Service Info

Change of design to protective dust cover

Part replacement - RIU: 566283.H195 replaced with 566283.01.H195

Image 1: The design of the dust-protection cover has been changed

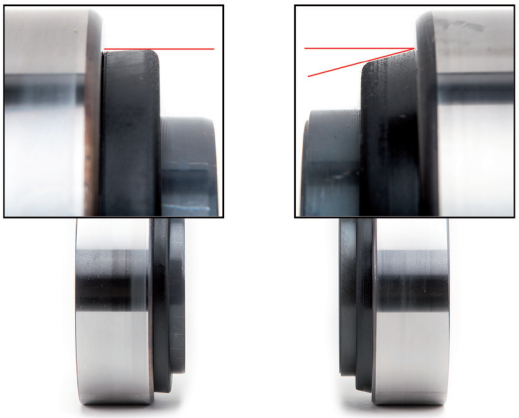
During fitment of Repair Insert Unit (RIU) part number 566283.H195, the protective dust cover may become twisted on some wheel hubs.
In the worst case scenario, a twisted protective dust cover may cause a bearing to become obstructed, thereby making it difficult for the wheel hub to turn or prevent it from turning altogether.

For this reason, a modified protective dust cover has been developed (see image 1).

As a result of this technical modification, part number 566283.H195 has been replaced with 566283.01.H195.
